Re: L-Bar Reclamation – Correction Sheets and Revised Table 4.1.1 for the Alternate Concentration Limits Application (ACL)

Please find enclosed two copies each of the revised figures for prediction of concentration contours at 200, 500, and 1000 years from present for the L-Bar site. These revised figures should replace the original figures from the ACL submittal dated August 28, 1998.

Figure 2.2.3.2.1

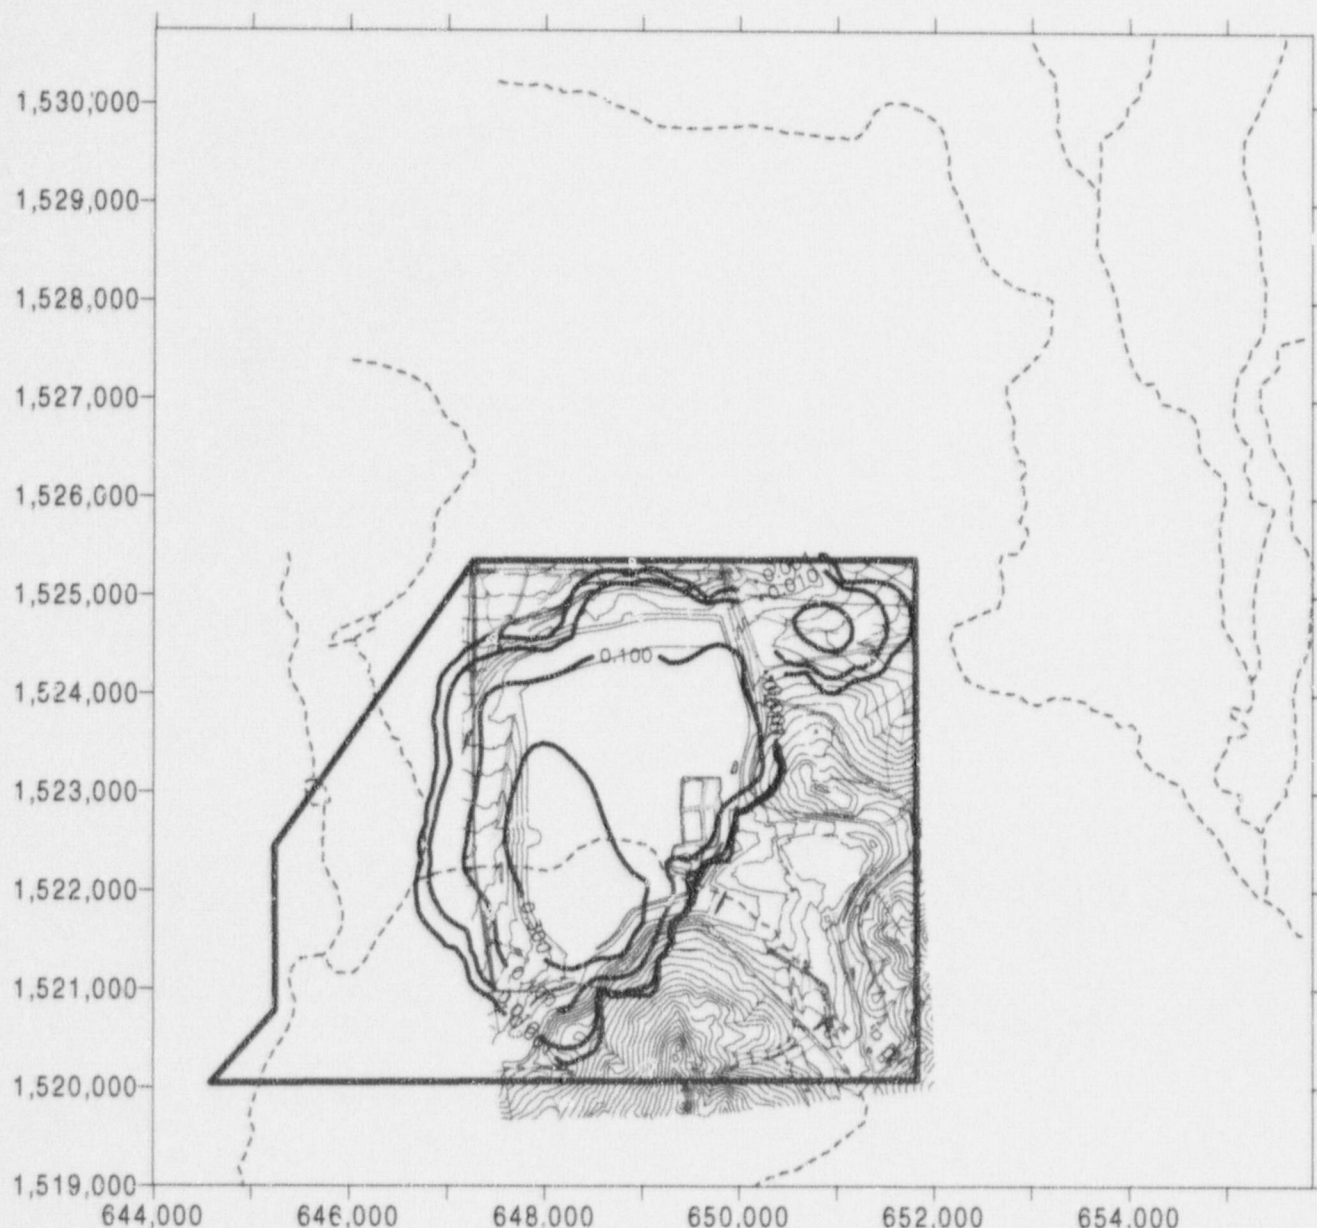
A nitrate plume of unknown origin had been previously identified in a region east of the tailings basin. Upon examination of the data for metals in wells to the northeast, we found that the area could represent a potential source area for NRC constituents of concern. The corrected isocontour plots for conservative constituents and for two rates of retardation present the result of inclusion of this source to the northeast. Contours of relative concentration from the tailings area and the separate northeast area are simulated separately using the model presented in ACL Appendix B1, then are shown together on the revised figures.

The contours displayed in the northeast have been revised as a result of additional modeling. The conclusions presented in the ACL remain valid, i.e. that predictive isocontours of contaminant concentration remain below the groundwater protection standard at all points of
